Summary Report of Stakeholder Engagement

Airspace Change Request ACP-2021-032

Author(s):	David Walters (david.walters@altitudeangel.com)
Document Version:	1.1 (17 January 2022)

Figure 1 A Closer look at the Proposed Final TDA Shape at SFC-800ft AMSL Following Feedback ON CAA 1:250K England South Chart

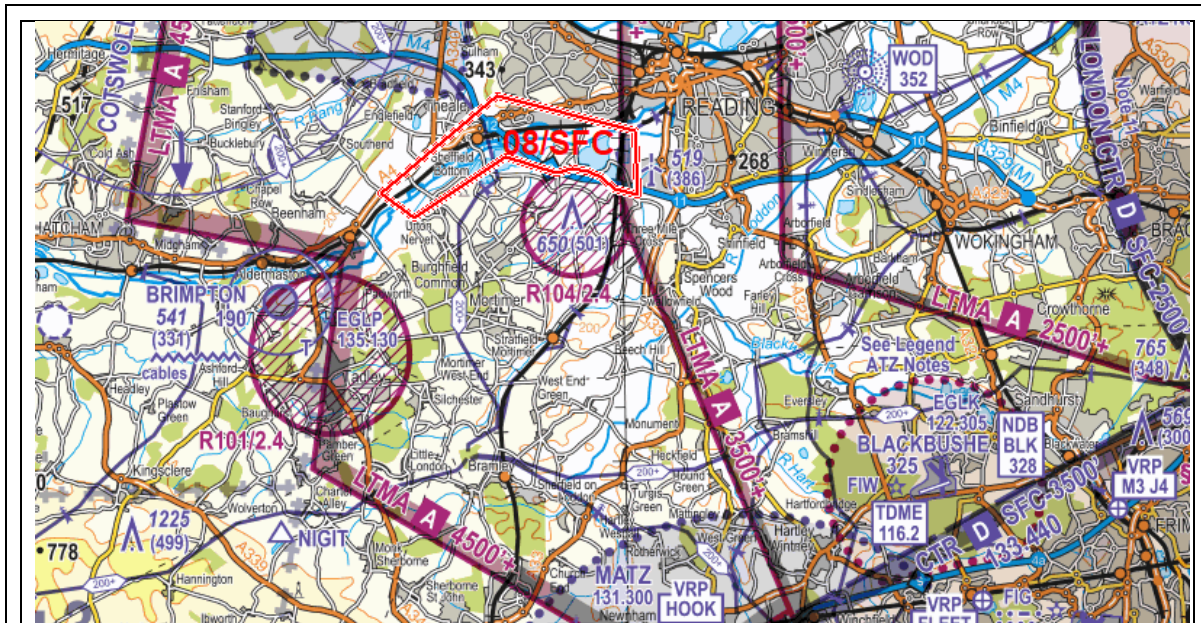
Some raised questions about the proposed upper limit of the TDA and requested we look to achieve 600ft AMSL, as opposed to 800ft AMSL detailed in our application.

Note: The Arc shape butts up next to the R104 Airspace of Burghfield

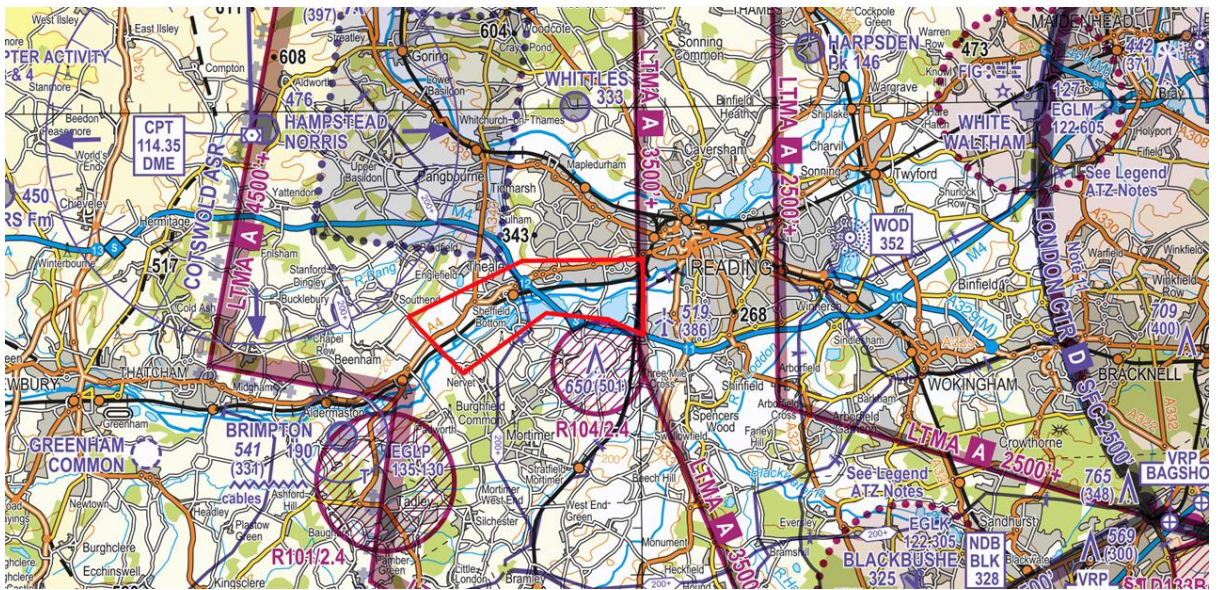
3. Whilst you have given detailed information on the area required for the TDA we would always request that this be presented on a current airspace chart, preferably the 1/4mil scale, considering the size of this proposed TDA. We appreciate that your Engagement Notice includes some representation but the chart used is not an appropriate scale. Actually, this issue is something we have consistently lobbied all sponsors and the CAA for as a fundamental requirement. The clue is in the name; it

is an *Airspace* Change Proposal where you need to engage with aviation stakeholders so it seems obvious that it would be necessary to represent the proposed Change on an *airspace* chart. This provides a level of clarity with regard to the impact any TDA could have on airspace users relative to existing airspace. It seems this is a common failure with virtually all UAV ACPs and we feel shows a level of ignorance of airspace matters. We are puzzled why the CAA don't insist on this as we cannot see them accepting an ACP from a major airport for revised airspace on a satellite map. The process is the same irrespective of what the Change is for so it seems sensible the same rules should apply. It would certainly enhance your application in the eyes of the CAA, I'm sure.

We have added an aviation chart to the uploaded and updated Stakeholder Letter V4 on the ACP Portal. We took the feedback from our first responses and uploaded the updated version. Since then we have obtained a digital copy of the VFR chart for the south and will be uploading it shortly. I do agree it would be better on the ACP planning tool if the CAA had the VFR Charts back loaded so we could draw directly on to them. It would be easier for everyone, I think!

Thanks, the 1:250,000 chart representation is much clearer and we appreciate your prompt and positive response to that request. It immediately shows proximity to any other airspace and any airfields and would be so much better if more drone sponsors were so motivated! It almost seems some purposely want to hide such proximities. A lesson for the CAA we think.

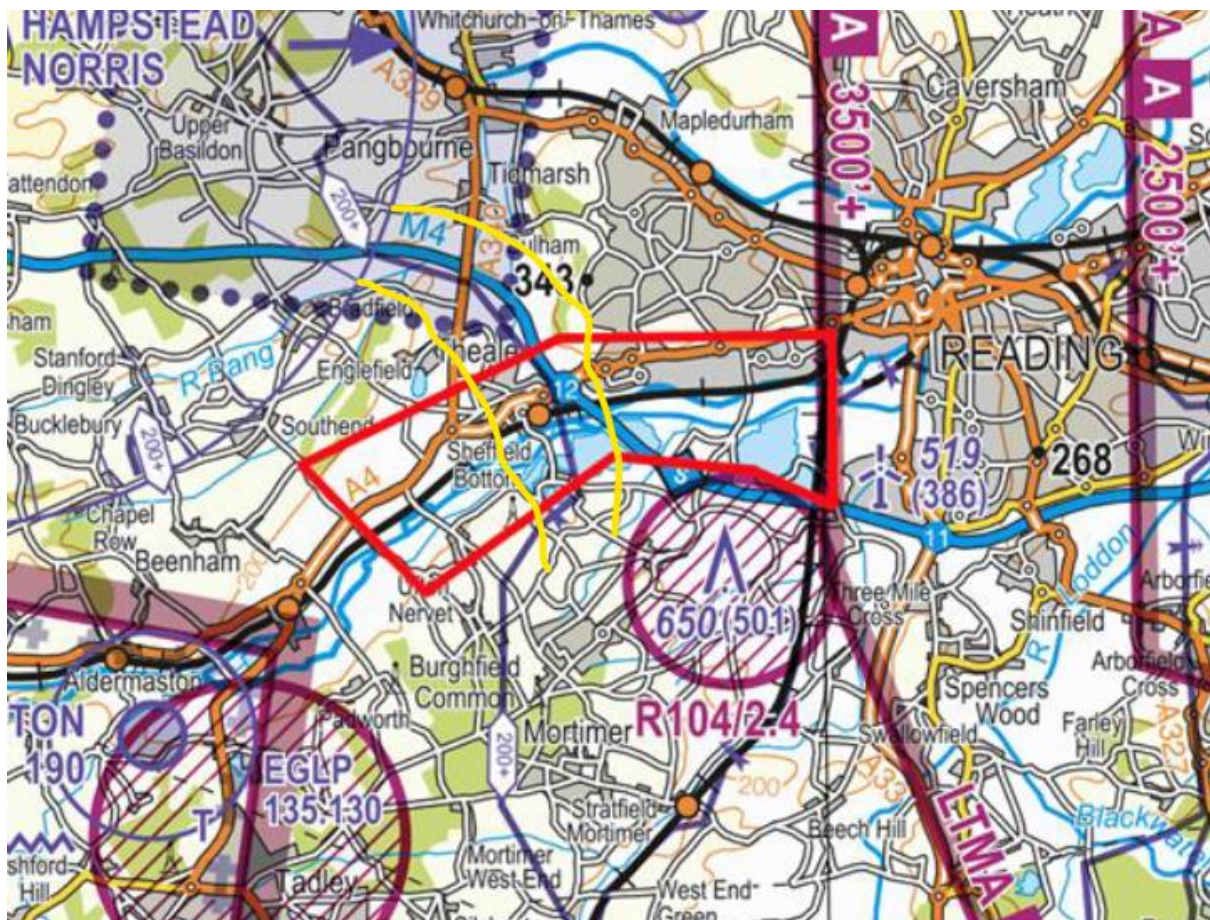
Hi,
 National Grid have a need to inspect its powerline as shown in the diagram below, generally by helicopter SFC-600ft agl, but possibly by EVLOS drone SFC-400ft agl.

Will access/deconfliction be easily provided on request?

If our TDA is active whilst you're looking to cross or do an inspection, a telephone number will be posted within the NOTAM. This line is only active when the TDA is. We can discuss timings and hold operations until your clear or complete if needed.

We also have ADSB receivers deployed, along with other sensors that support our DAA of Manned Aircraft, so we should see you also.

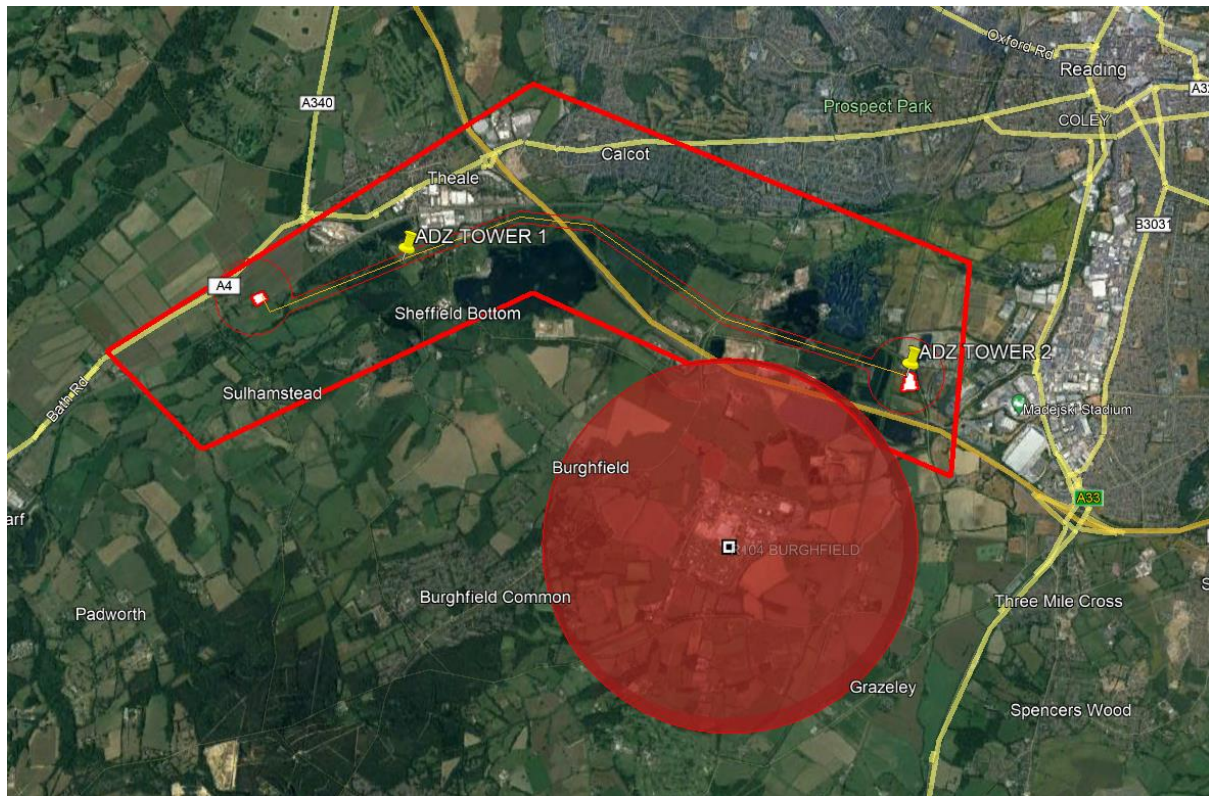
Thanks for your offer, I'll try and make one of the calls when our Pilots confirm attendance. However, I do have a couple of questions if you don't mind, I've looked at the VFR Chart and noticed your FDA is extremely close to our Restricted Airspace do they intersect at any point?

Our TDA Proposes to follow the outer edge of your Curve on R104. On our first submission there was a slight gap which the CAA asked us to close. The actual route the drones will fly is the orange centre line which is a good 350m away from the R104 TDA. The Red lines which sit either side of that is our emergency buffer zone. Then we have our TDA over the top of that.

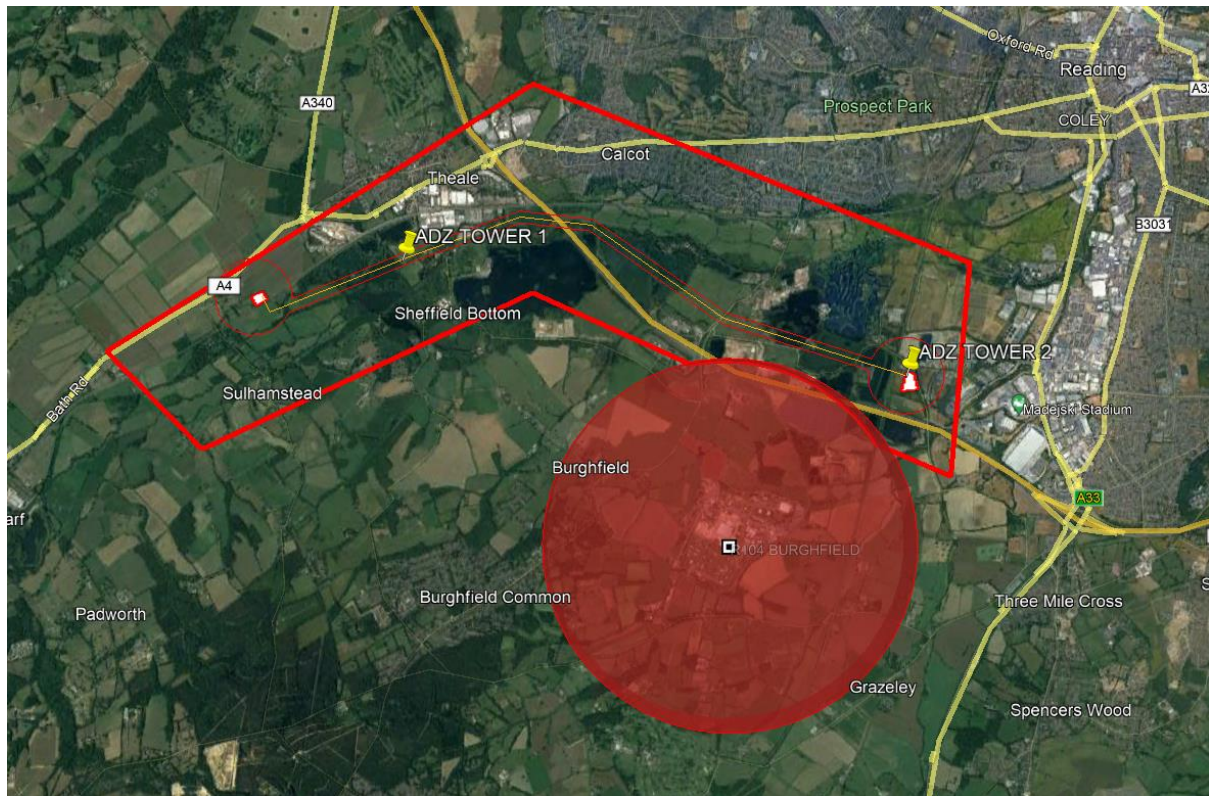
Thanks for your offer, I'll try and make one of the calls when our Pilots confirm attendance. However, I do have a couple of questions if you don't mind, I've looked at the VFR Chart and noticed your FDA is extremely close to our Restricted Airspace do they intersect at any point?

Our TDA Proposes to follow the outer edge of your Curve on R104. On our first submission there was a slight gap which the CAA asked us to close. The actual route the drones will fly is the orange centre line which is a good 350m away from the R104 TDA. The Red lines which sit either side of that is our emergency buffer zone. Then we have our TDA over the top of that.
